Tesla, Inc. Service Bulletin		<i>Inspect Tonneau Cover for Exposed Water Management Channel</i>			
SB-25-11-001 February 25, 2025							
Classification				Section/Group		Mobile Service	Configuration
Repair Bulletin				11 - Closures		Cannot Perform	All
Model		Model Year		Country/Region		Build Location	
Cybertruck		All		United States		Giga Texas	
The model(s) and model year(s) listed are a general approximation of the affected VIN list. Refer to the VIN/Bulletin Tracker or Customer/Vehicle profile to determine applicability of this bulletin for a particular vehicle.

Figure 1

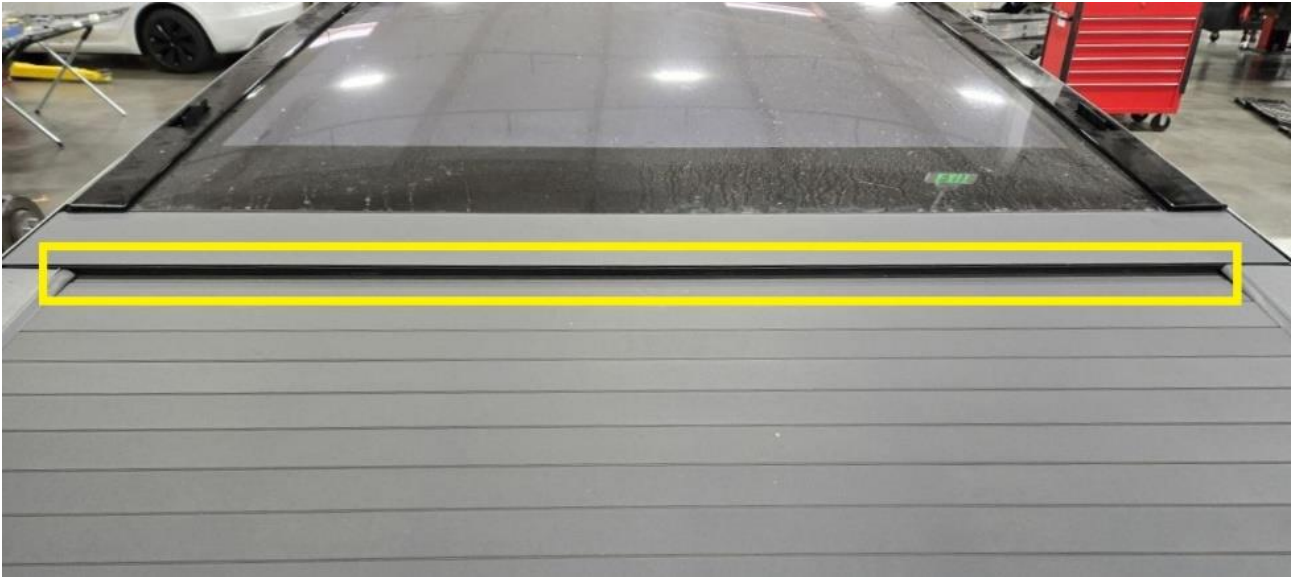
Inspect the tonneau cover for a horizontal gap between the water management slat and the tonneau applique that exposes the tonneau slat water management channel (Figures 1–3).

- If the water management channel is not exposed (Figure 2), discontinue this procedure and use correction code S022511001. Continue diagnosis if excessive water into the cargo bed needs to be investigated.
- If the water management channel is exposed (Figure 3), install an additional slat into the tonneau cover (refer to Service Manual procedure [1120122007](#)). Use correction code S032511001.

Figure 2 – No Gap Between Water Management Slat and Tonneau Applique; Water Management Channel Not Exposed

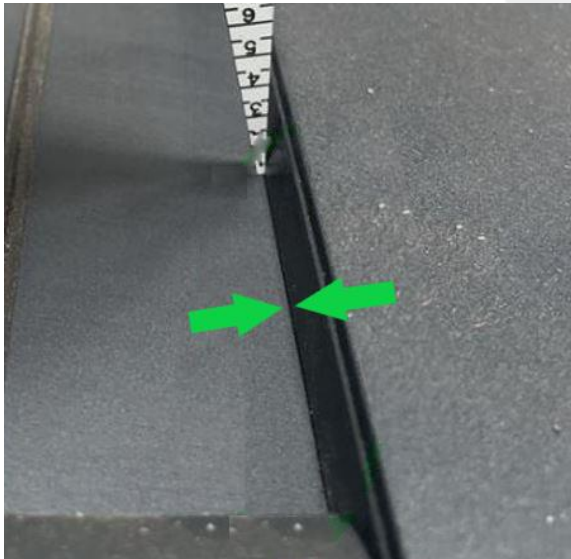
**NOTE:** There should be no gap horizontally between the water management slat and the tonneau applique (Figure 2).
